Product Change Notification: PCN-26-284720

Seal ring for HQ-005/7-M

CHANGE SEAL

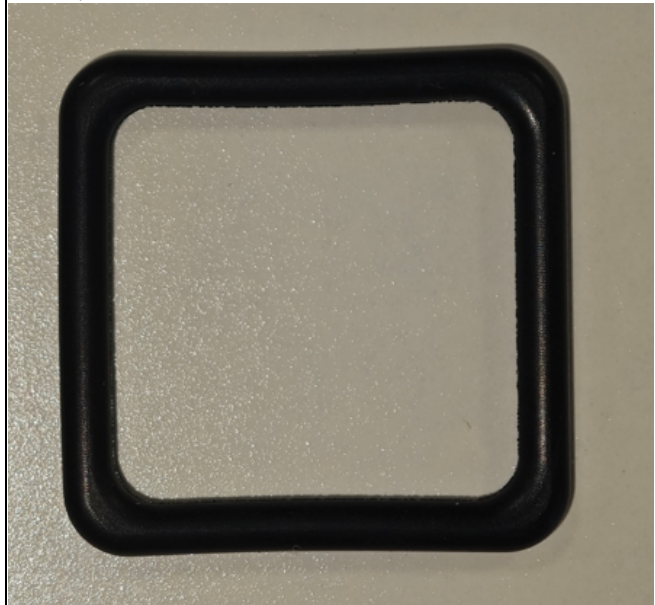
HQ-005/7-M Old Seal

HQ-005/7-M New Seal

Optimize our clamping force while ensuring watertightness.
